Tree Planning Report & Arboricultural Method Statement

'The Slips',
West End Lane,
Henfield,
BN5 9RG

Revision A_26.01

- 1.4 Further to submission of this report and comments from the Local Planning Authority ('LPA') tree officer, the proposed site & drainage plans have been amended to negate the majority of the concerns raised by the tree officer. With this in mind, text in red is an addition to the original submission. Furthermore, ~~cross-through text~~ can be disregarded or is no longer relevant.

Drawing No: TPP 03 SHEET 3 OF 3

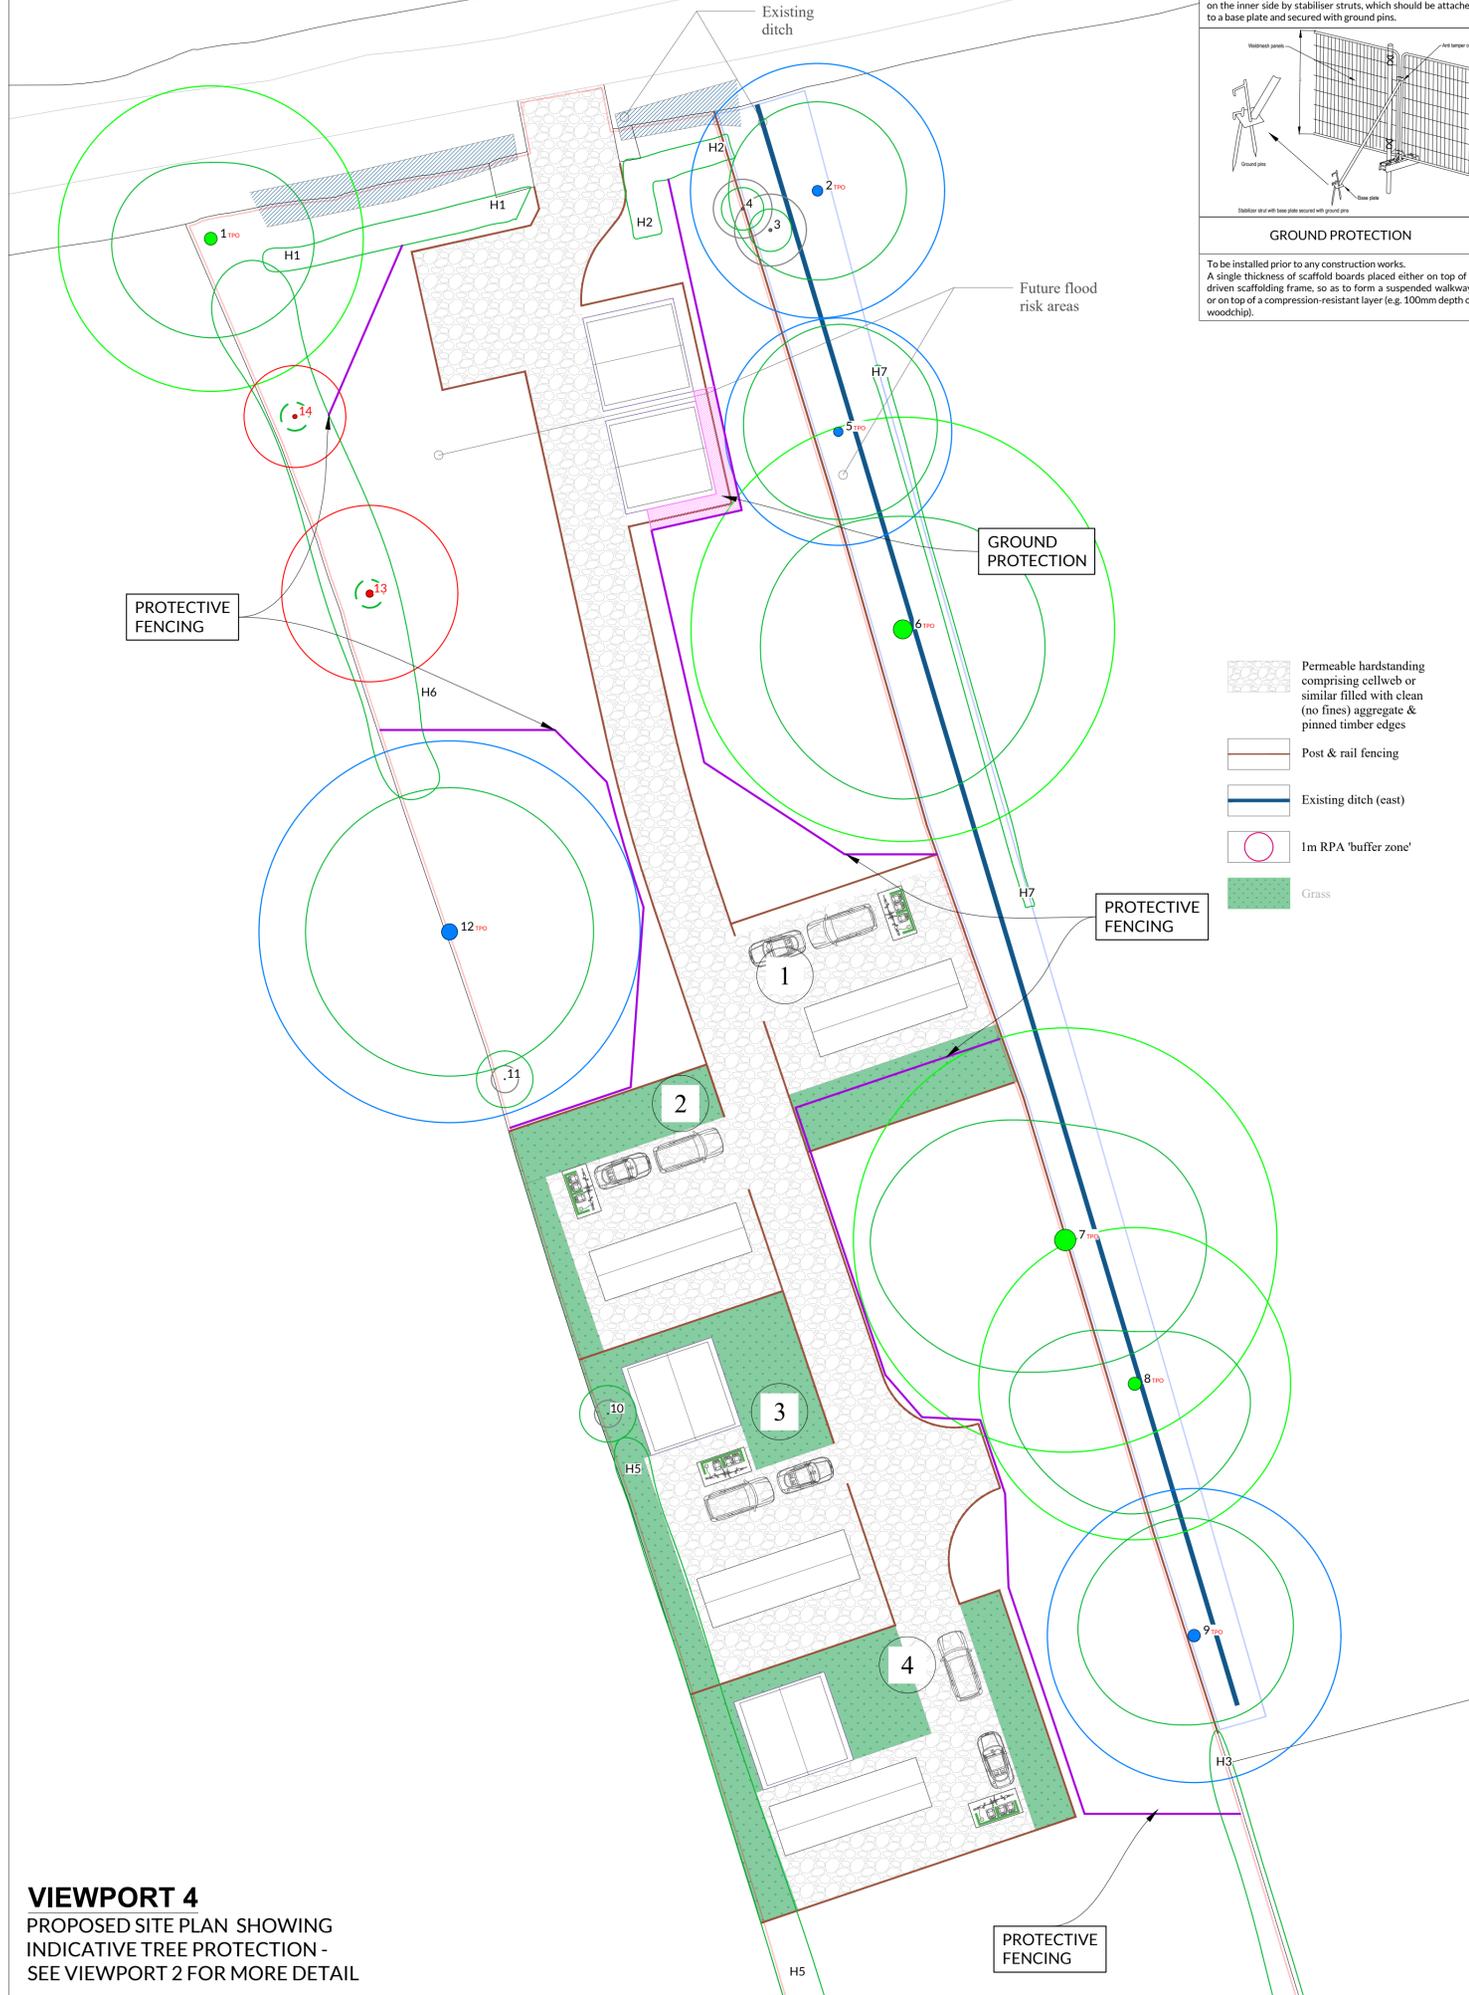
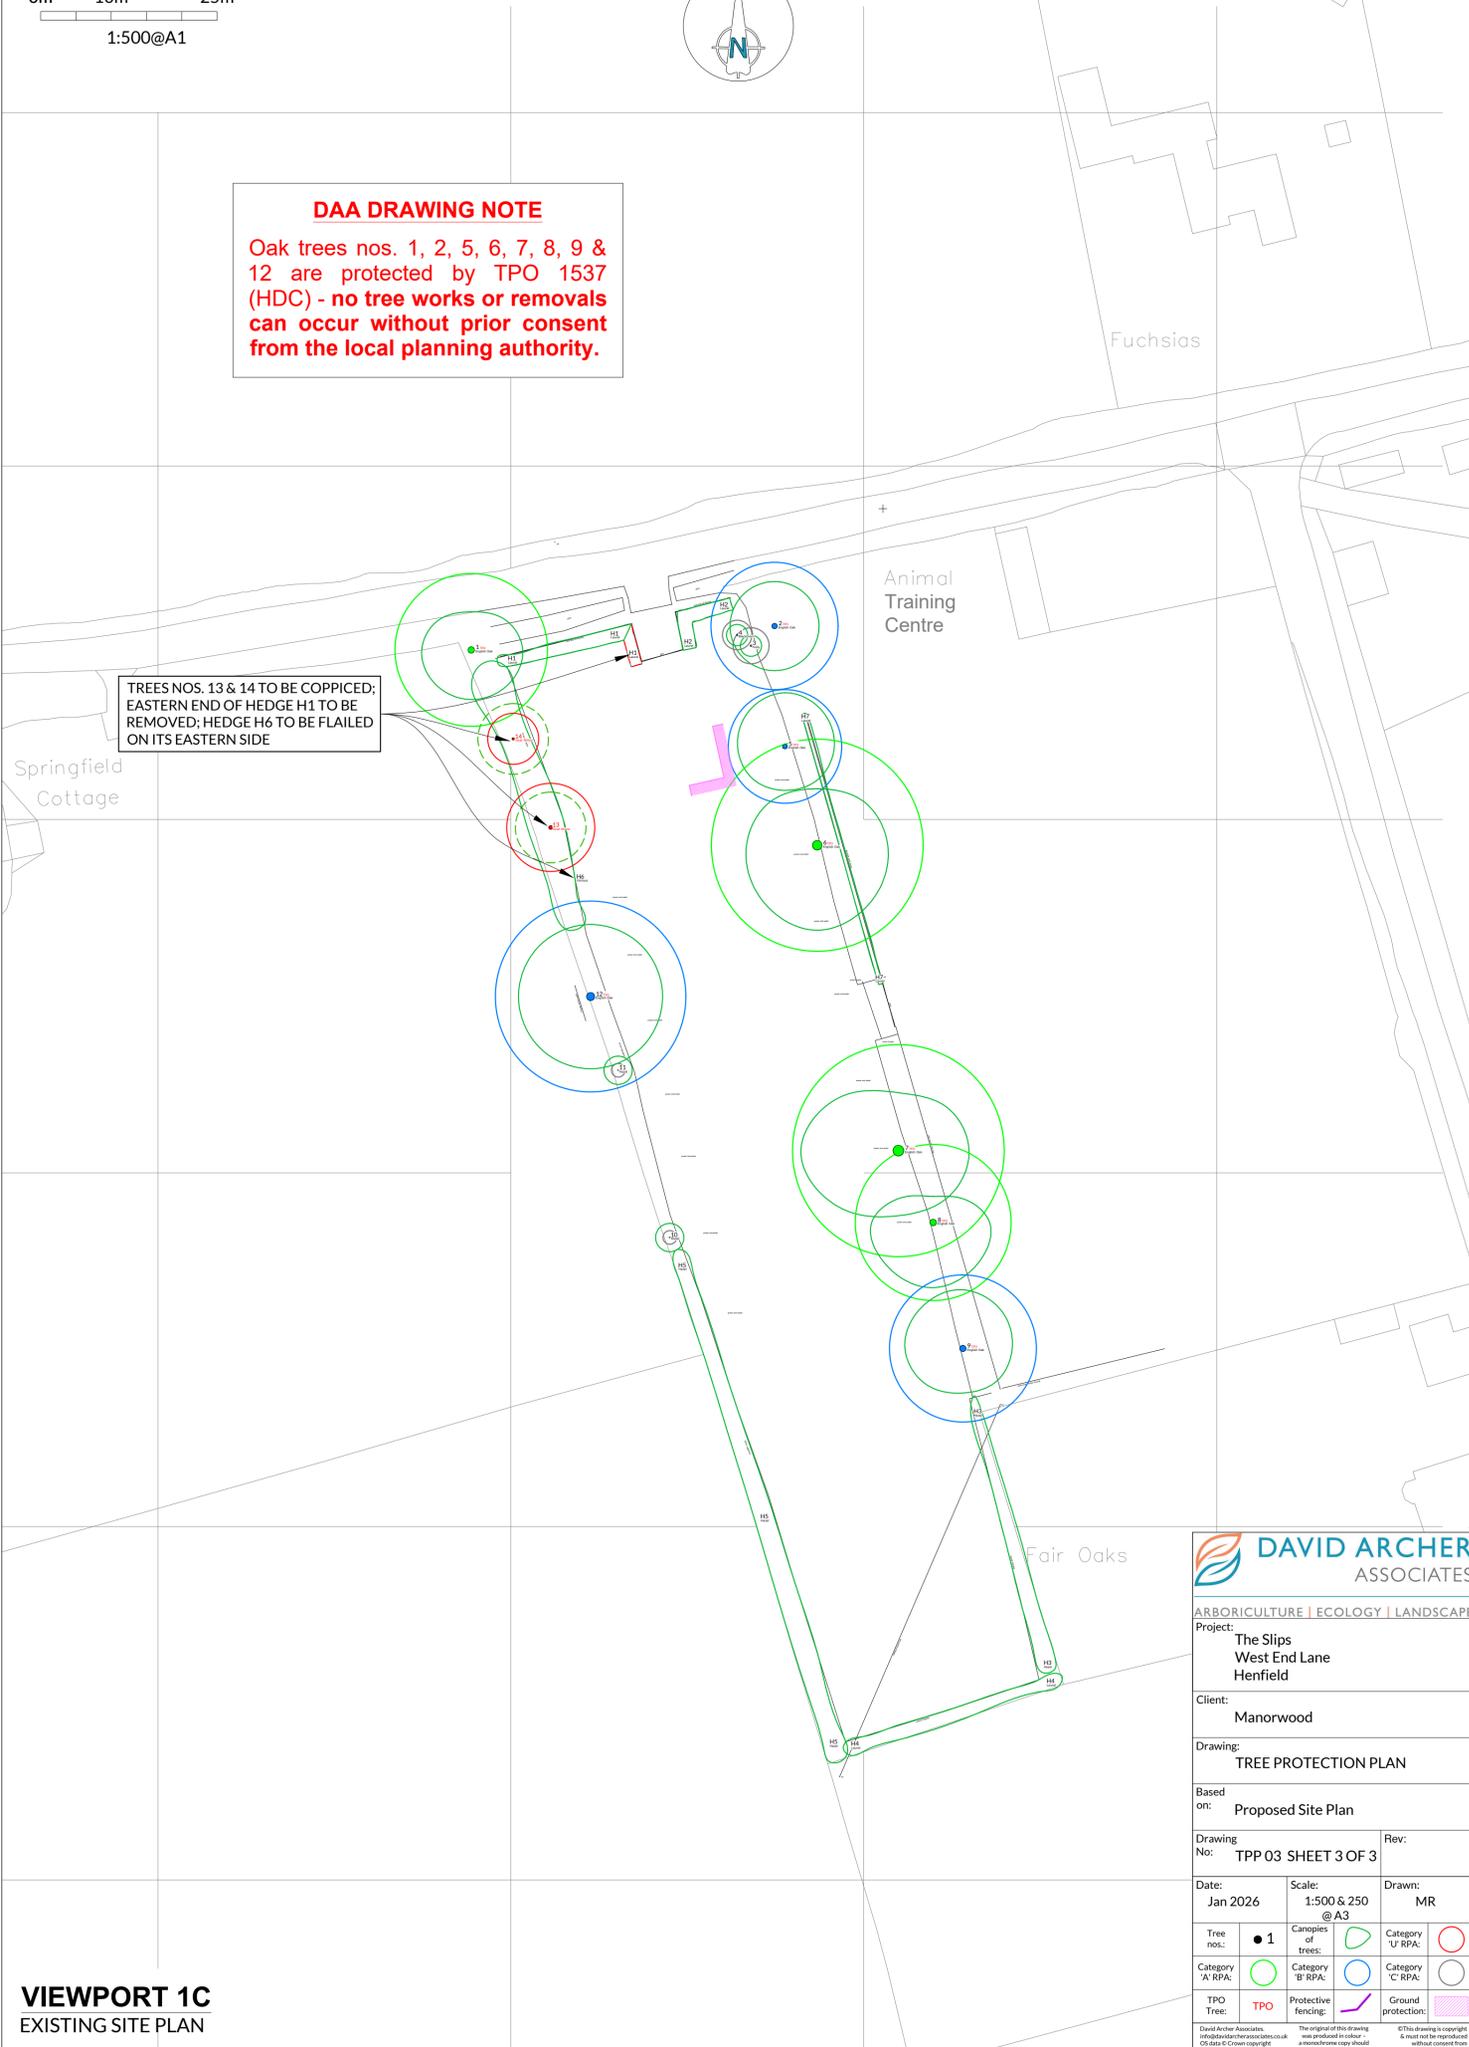
- 1.7 Due to increasing costs, one change from the existing submission is that the Day rooms will no longer be prefabricated. To allow for construction space, this has resulted in a small amount of ground protection being proposed to the west of tree no. 5.

- Sheet 2 is the proposed drainage plan.
 - Sheet 3 shows the proposed site plan with the proposed tree protection.

- 2.11 With this 1m *non-industry* buffer zone in mind, there are only two areas across the entire site, where the proposals fall into this additional buffer zone. These instances are:

- Within the 1m *non-industry* buffer zone of trees nos. 7 & 8, the proposed access drive.
 - Within the 1m *non-industry* buffer zone of tree no. 12, the proposed access drive.

- 6.1 In order to provide construction working space, where the setting back of the protective fencing results in unmade ground within the RPA of retained tree no. 5 being exposed to construction damage, temporary ground protection shall be put in place for the duration of the construction period, in the locations denoted by magenta hatching on the TPP (Sheet 3).
- 6.2 The ground protection shall comprise a single thickness of scaffold boards placed either on top of a driven scaffolding frame, so as to form a suspended walkway, or on top of a compression-resistant layer (e.g. 100mm depth of woodchip),
